APPLICATION NO.	FILING DATE	FIRST NAMED INVENTOR	ATTORNEY DOCKET NO.	CONFIRMATION NO.
10/046,285	01/16/2002	Jae Sung Kim	RPL-0025	2364

**SUPPLEMENTAL**  
**Office Action Summary**

## **SUPPLEMENTAL DETAILED ACTION**

Fig. 4

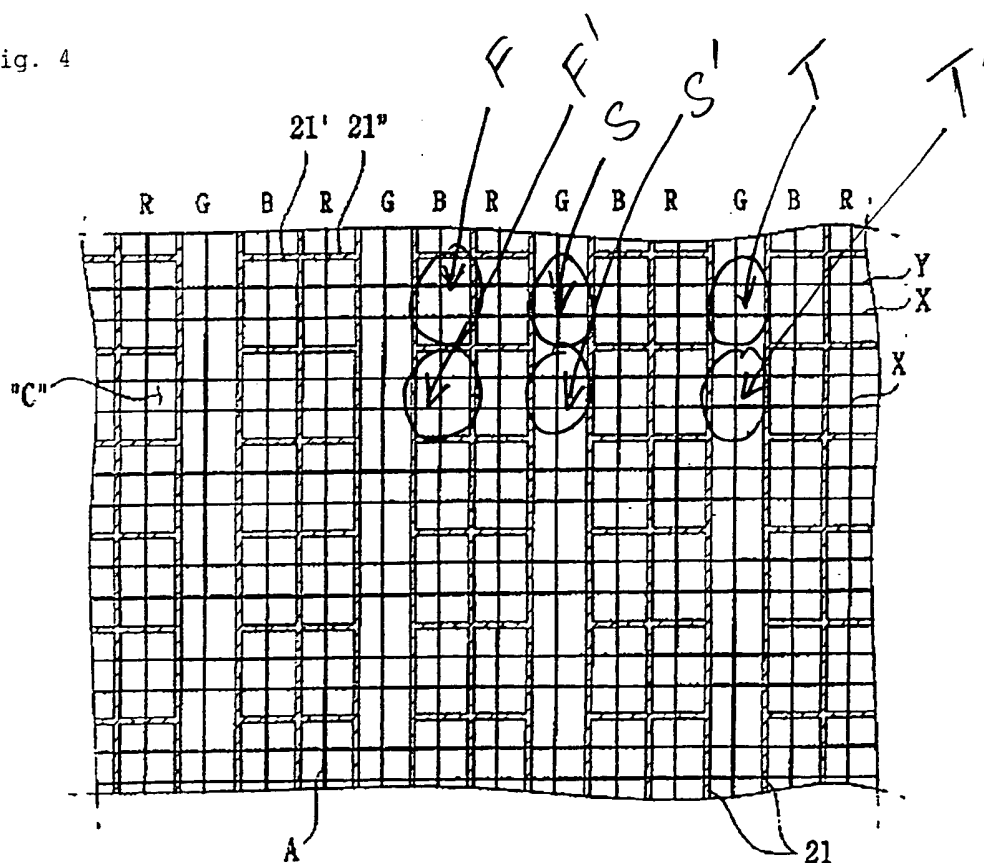
Regarding claims 9-11, the admitted prior art shown in figure 4 clearly discloses plasma display device comprising:

three sets of discharge cells are separated by barriers;

each cell of first blue discharge cells (F, marked by examiner) is separated from another adjacent cell of the first blue discharge cells (F', marked by examiner);

each cell of second set of discharge cells (S, marked by examiner) is separated from another adjacent cell of the second discharge cells (S', marked by examiner); and

each cell of third set of discharge cells (T, marked by examiner) is separated from another adjacent cell of the first blue discharge cell (T', marked by examiner).
